ENCLOSURE 1

MFN 12-112 Sup 2

Markup of GESTAR II US Supplement

**Figure S-4. Illustration of Scram and Controlled Entry Region Boundaries, and the BSP Boundary for BSP for DSS-CD [per Reference S-104](#)**

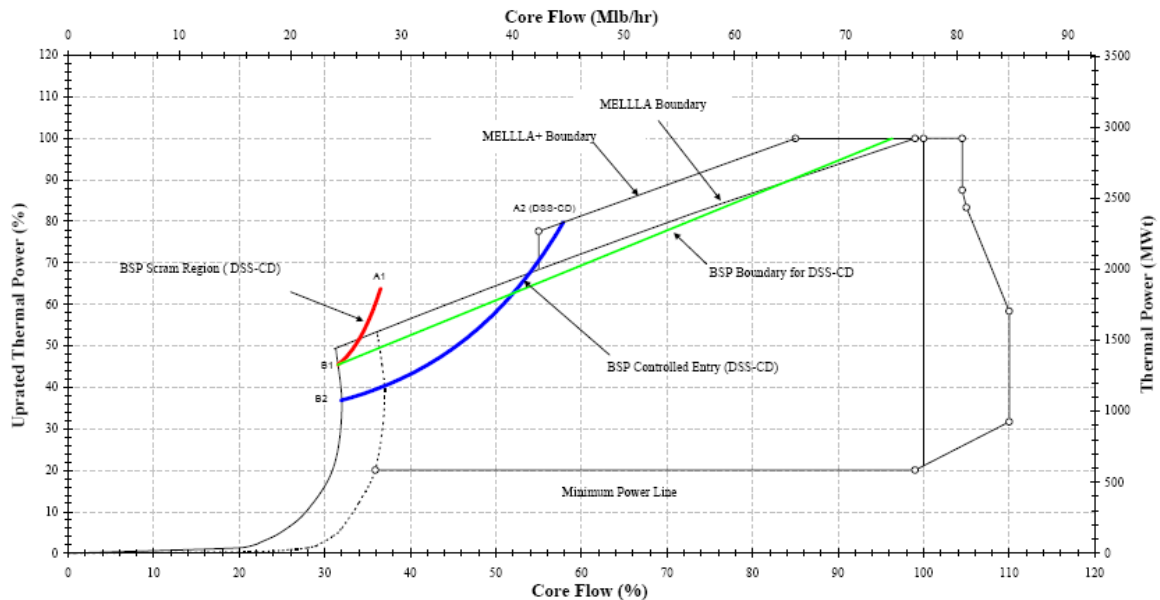
The typical calculated stability region boundaries and the BSP Boundary are illustrated in Figure S-4; the three endpoints A1, B1 and B2 are calculated based on a core DR criterion of 0.80 while the A2 endpoint is calculated based on a core DR criterion of 0.60. The 0.60 criterion for the A2 endpoint (as illustrated in Figure S-4) provides additional stability margins for operation at off-rated conditions and for a two-pump trip to natural circulation flow.

Please note that the actual implemented BSP [region](#) boundaries might be larger due to the Base BSP region definitions. The Base BSP regions for DSS-CD are defined in Reference S-~~103~~104.
